**LETTER OF OBJECTION TO DA 2018/1708 FOR
FOR DEMOLITION AND CONSTRUCTION OF A BOARDING HOUSE AT 195-197 SYDNEY RD,
FAIRLIGHT**

Reference is made to the above Development Application (DA) for No 195-197 Sydney Road, Fairlight (the subject site) which seeks consent for demolition works and the construction of two, 3 and 4 storey buildings containing a total of 75 rooms capable of housing 126 occupants. The DA also proposes the construction of a 2 storey basement car park containing 38 car spaces.

We act on behalf of the owners of No 189 Sydney Road (Strata Plan 22590), an adjoining property to the east.

Figure 2: view looking north of subject site with 189 Sydney Rd to the right (source: Modularium)

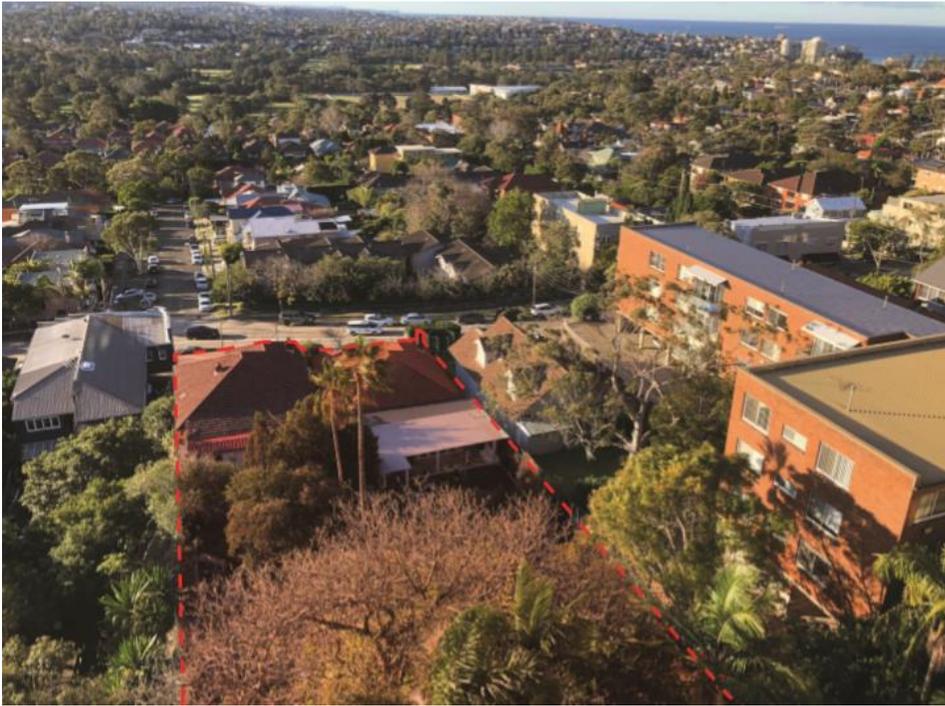
Of the 15 units at 189 Sydney Road, 9 have views over the subject site from their balconies and windows. Figure 2 below shows the balconies and windows along the western elevation of No 189 Sydney Road, in relation to the subject site. These west facing windows and balconies enjoy views over the subject site.
